ADDENDUM 3

ADDENDUM DATE: November 19, 2024

PROJECT: Onslow County Senior Services Center Renovation
4024 Richlands Highway
Jacksonville, NC 28540

ARCHITECT: Smith Sinnett Architecture, P.A.
4600 Lake Boone Trail, Suite 205
Raleigh, North Carolina 27607

1
A0-06 **OVERALL ROOF DEMOLITION PLAN**
1/8" = 1'-0"

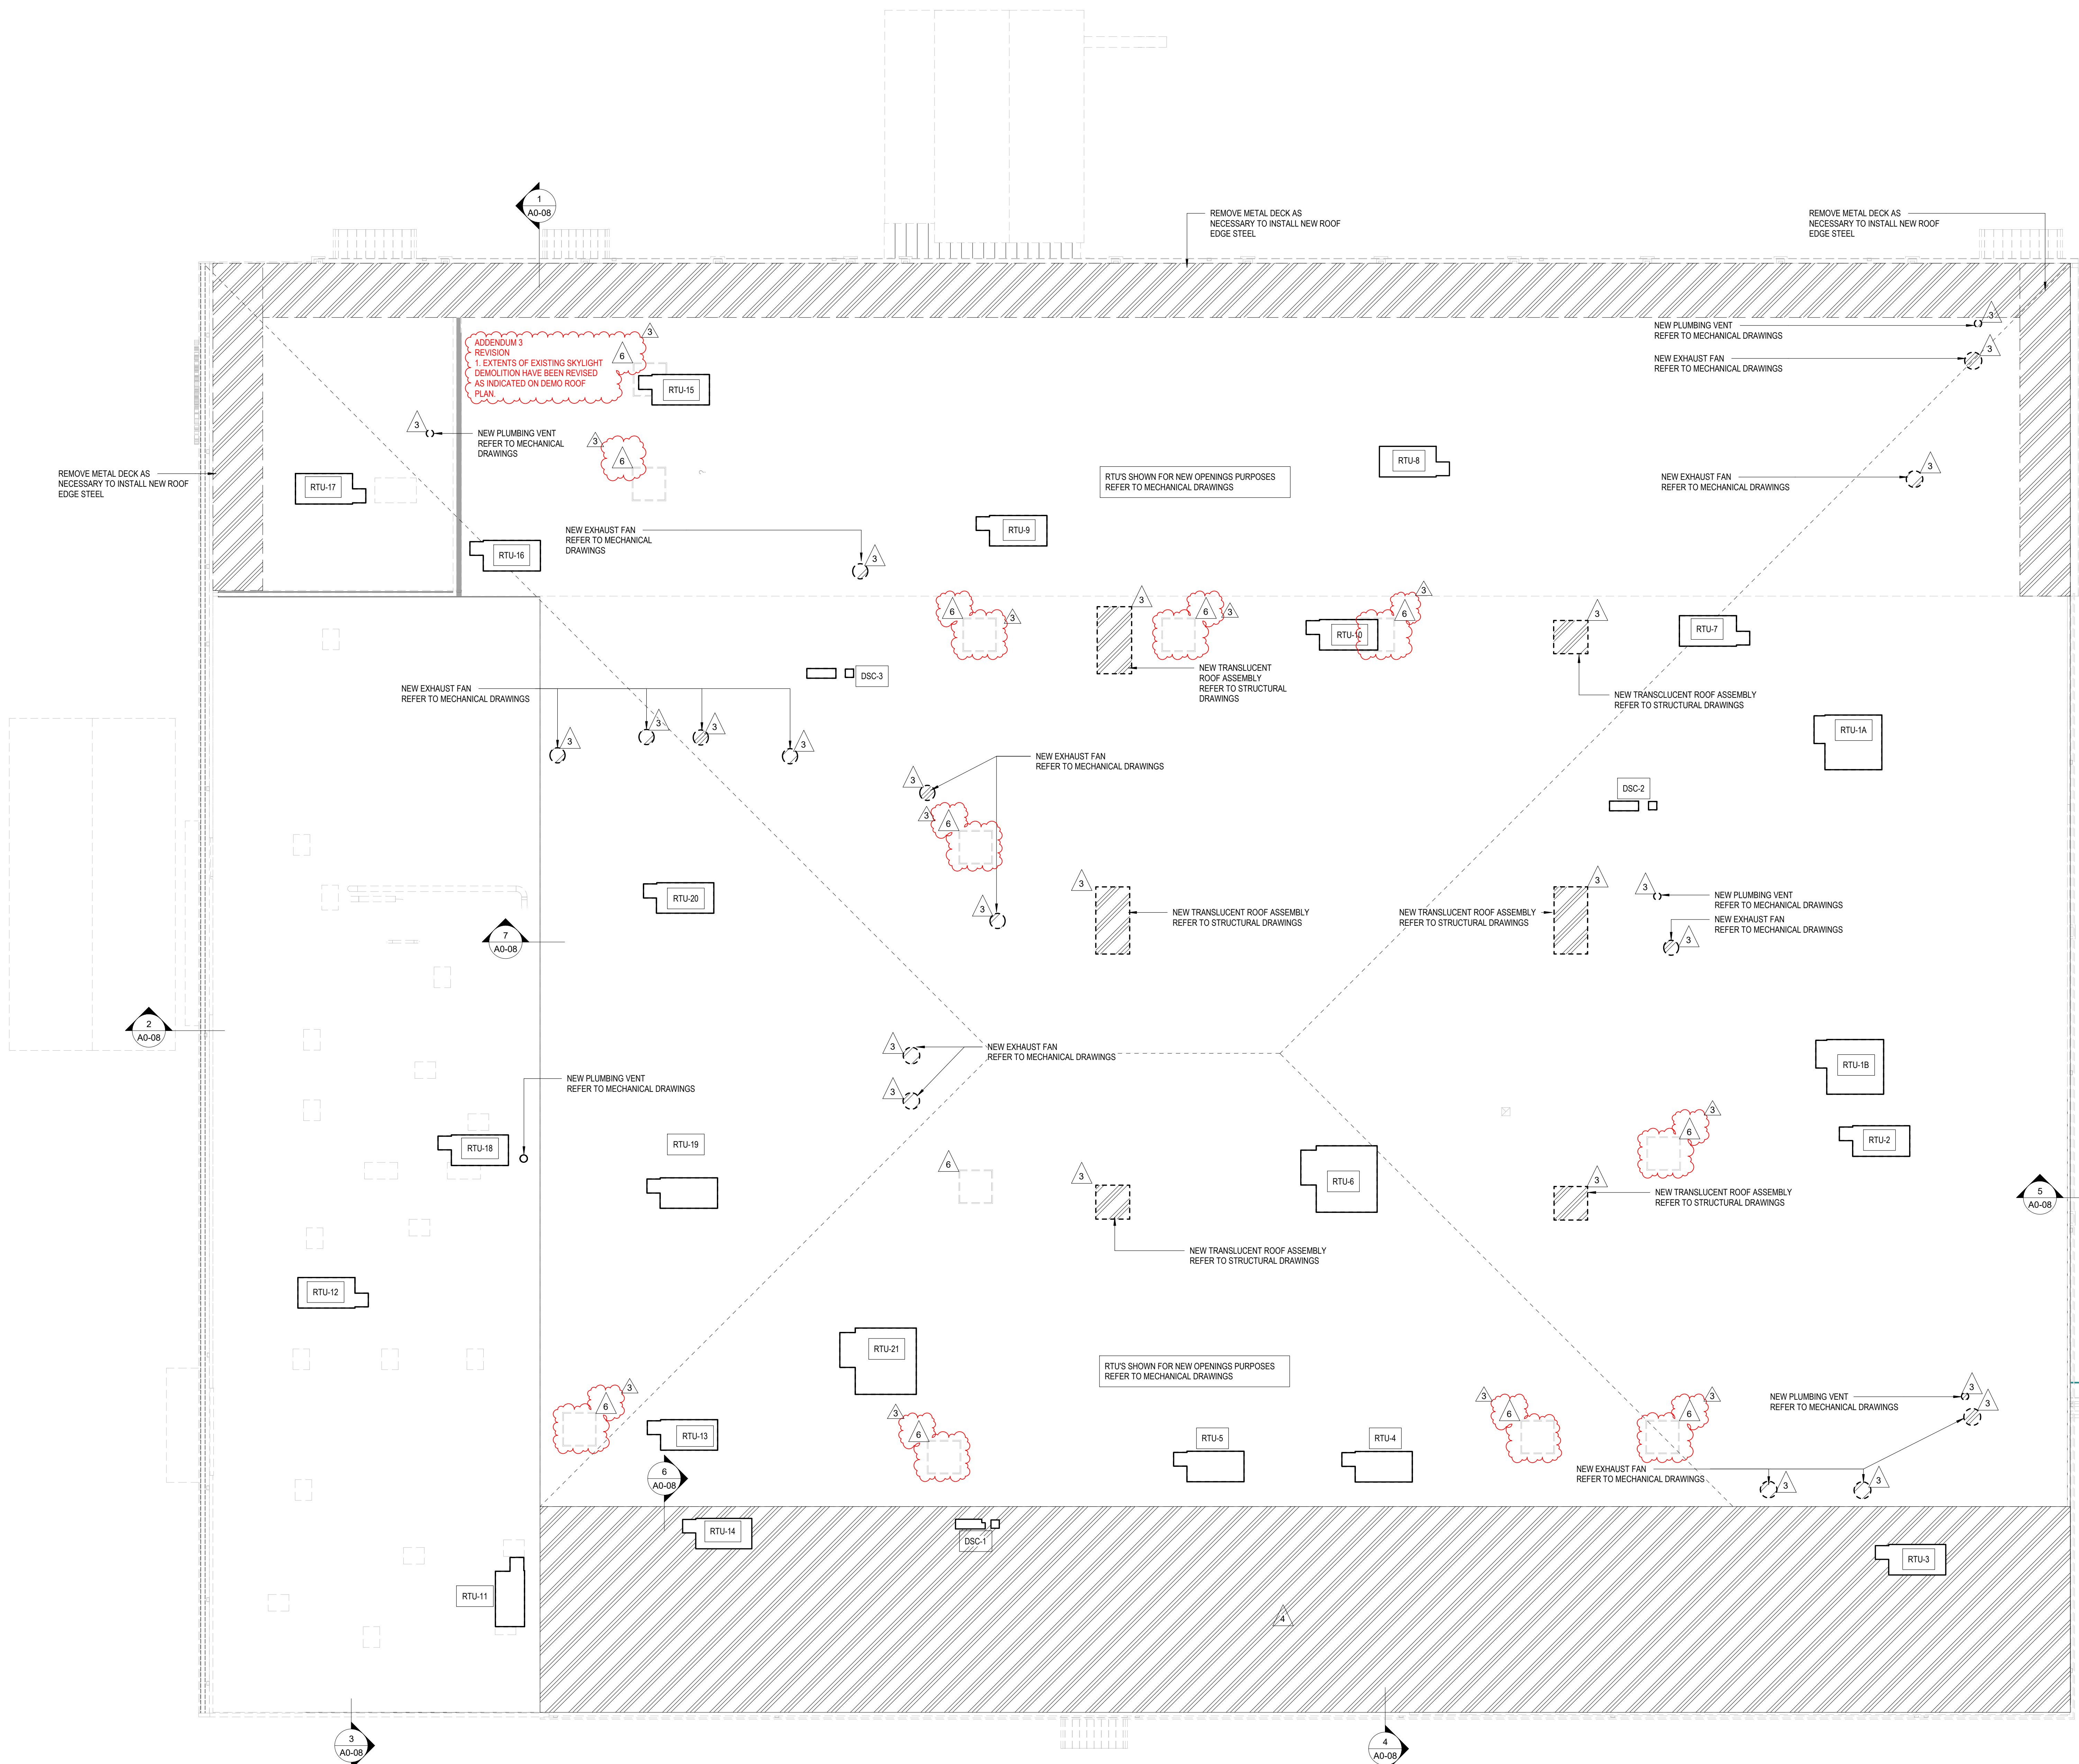
- Item 52 Sheet A0-04: REPLACE the sheet in its entirety with the attached sheet A0-04.
Note the following revisions:
- Four existing joists to be removed. Refer to S1-01 attached to this addendum.
- Item 53 Sheet A0-06: REPLACE the sheet in its entirety with the attached sheet A0-06.
Note the following revisions:
- The extents of existing skylight demolition have been revised as indicated on demo roof plan.
- Item 54 Sheet A1-02: REPLACE the sheet in its entirety with the attached sheet A1-02.
Note the following revisions:
- The aluminum window between Lobby 101 and Reception 102 changed to AL9.

4 ENLARGED DIMENSION PLAN - TOILETS 115B AND 115C
A4-01 1/4" = 1'-0"

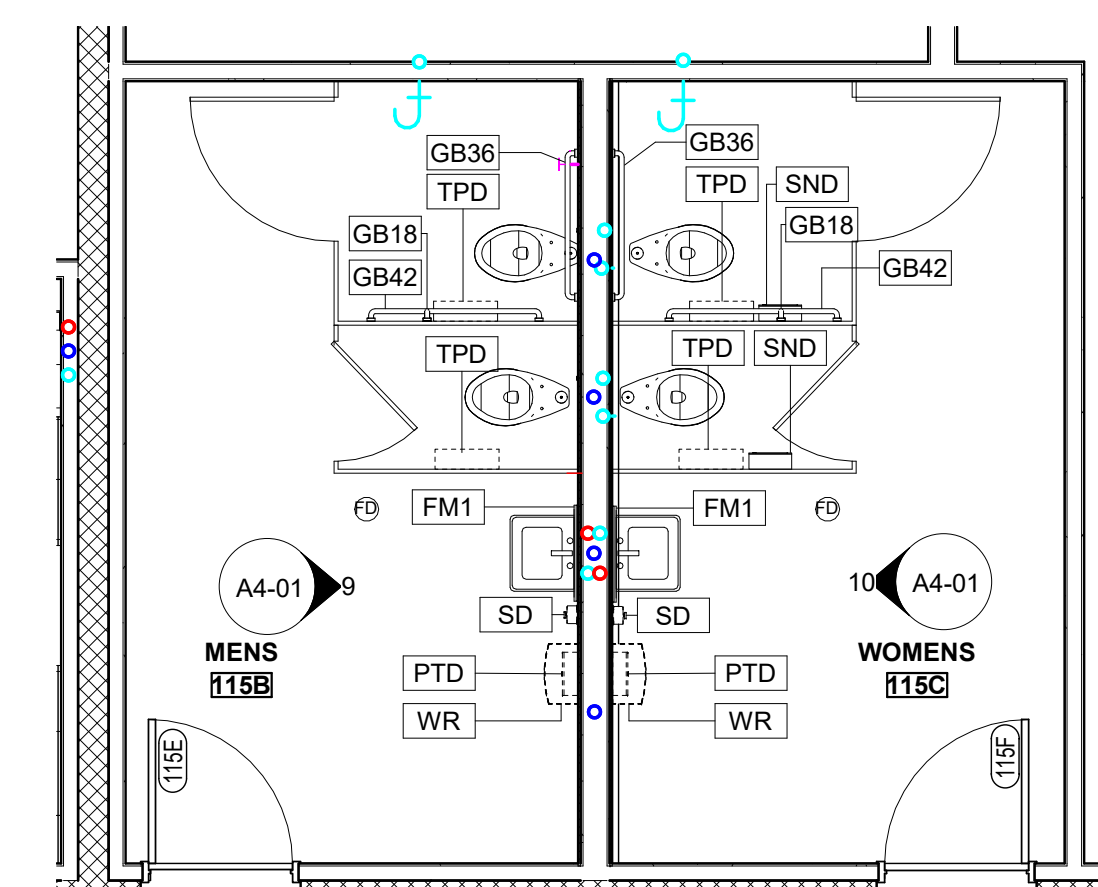
- 4/A4-01: Water closet in Mens 115B and Womens 115C shall be 1'-5" from face of toilet partition to center of water closet as indicated on plan.
 - Note per ICC A117.1-2009 Accessible and Usable Buildings and Facilities, 604.2 Location the centerline of an accessible water closet shall be 16 inches minimum and 18 inches maximum from the side wall or partition. The change from 1'-6" (18") to 1'-5" (17") from the centerline of the water closet to the face of the partition is intended to provide 1" of tolerance.

10 102 RECEPTION - EAST ELEVATION
1/4" = 1'-0"

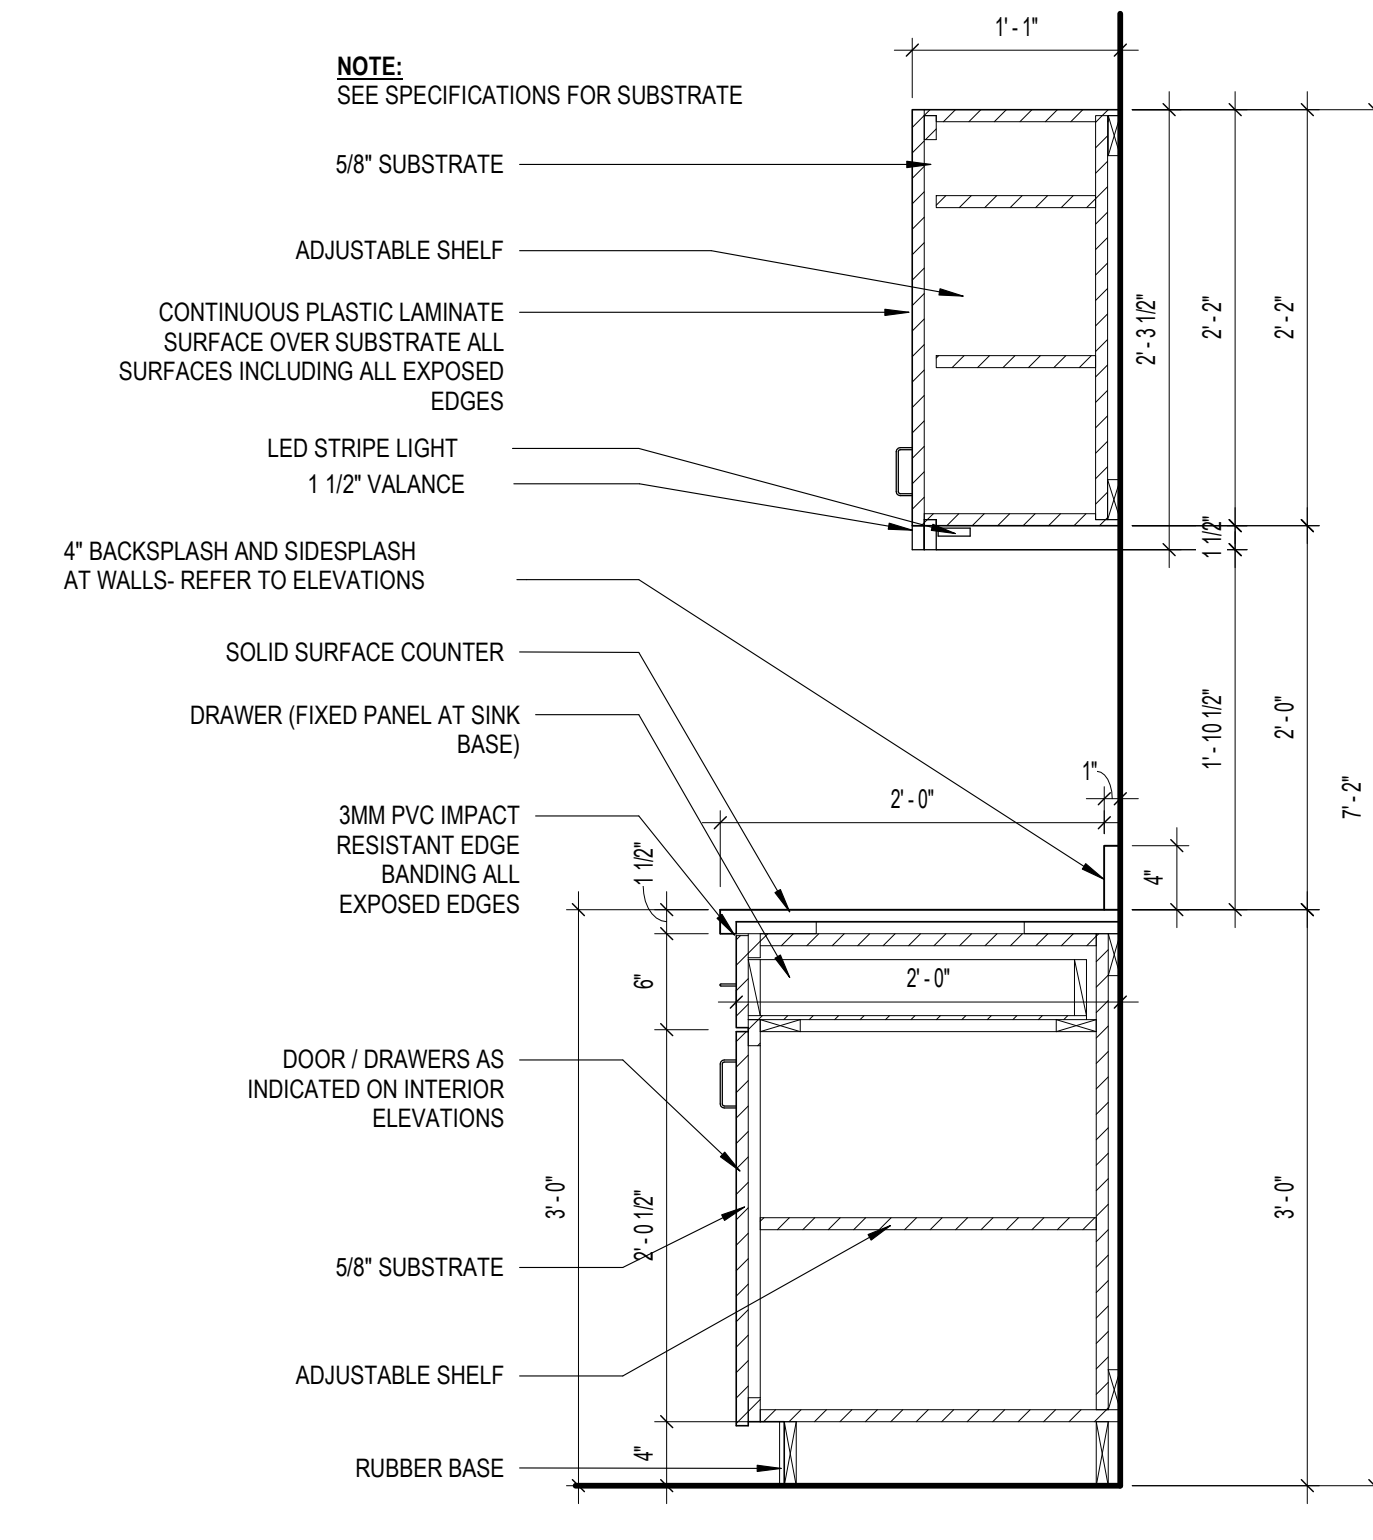
- 5/A4-10: Revision of PL-2, Wall surface and Base Cabinets.
 - 10/A4-10: Top of countertop at Reception 102 shall be at 2'-6" above the finished floor. Backsplash added to countertop.

- 10/A4-10: Clarification of plastic laminate for casework in Reception 102.
 - 11/A4-10: Top of solid surface countertop shall be at 2'-10"
 - 15/A4-10: Addition of Lobby 101 countertop plan.

4 ALTERNATE 6C - REFLECTED CEILING PLAN
 A9-10 1/2" = 1'-0"

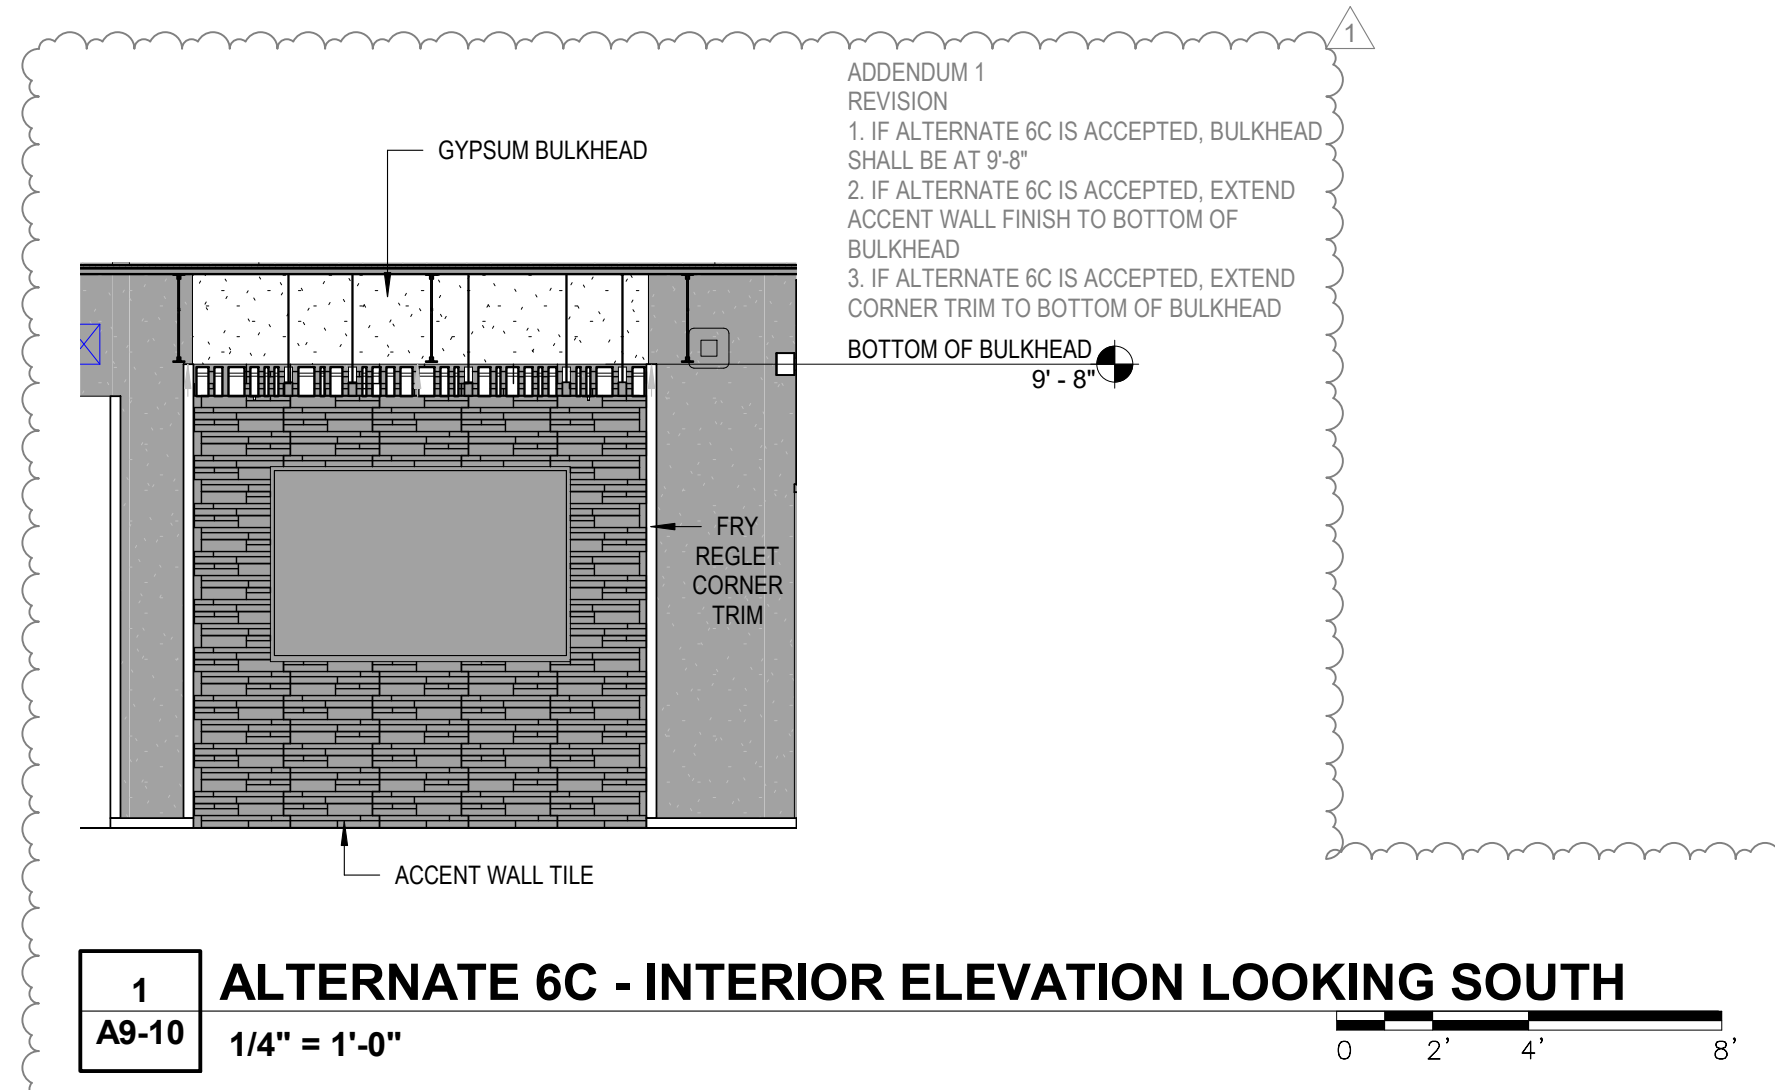
- Item 62 Sheet A9-10: REPLACE the sheet in its entirety with the attached sheet A9-10.
Note the following revisions:
- DELETE General Notes, Item 2. "2. If alternate 6C is accepted, alcove shall be left exposed, see 4/A9-10" from general notes on A9-10".

ADDENDUM 3 REVISION
 1. REMOVE GENERAL NOTE 2 FROM ALTERNATE 6C LEGEND.
